May 4, 2021

**Re: Cross Creek – PA-C2 – Library Time (#1515272)/Pre-Application Meeting held February 4, 2021**

*Standards and Issues:*

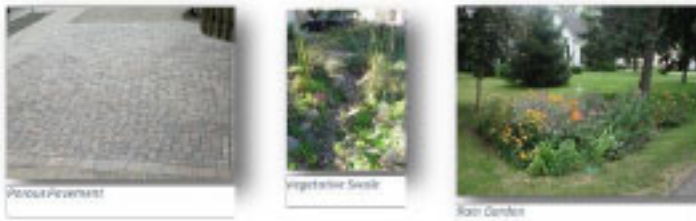
- Section 146-4.7.5 L. (Site Entryways and Intersections)  
Provide a distinctive landscape feature at each site entrance. Distinctive landscape features should consist of specimen quality plant material that will provide visual interest during all seasons.

***Response: Area of distinctive landscaping provided at entrance monument.***
